Product Change Notice (PCN)

PCN Number: PCN-0451188R-01

Product(s) Affected: *PJ-051A, PJ-051B, PJ-051AH, PJ-051BH*

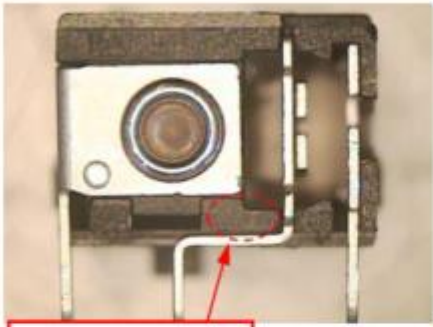
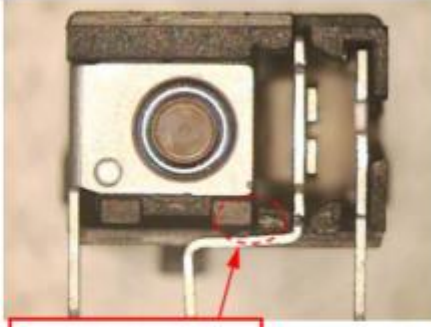
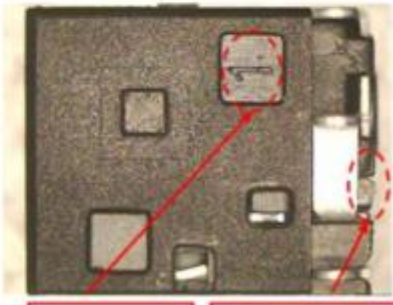
Reason(s) for Change: *The existing molds of PJ-051A, PJ-051B, PJ-051AH, and PJ-051BH are unable to maintain efficient production. To ensure the quality and lead-time of production, a re-development of the mold has been processed. We have taken this opportunity to also optimize the product design to enhance the quality. The new mold will optimize the design, enhance the appearance, the electrical structure while function will remain the same (The comparison photos are available below).*

New version	Current version
Back	 <p>Without gap</p>	 <p>With gap</p>
Bottom	 <p>Smaller mark Without gap</p>	 <p>Bigger mark With gap</p>
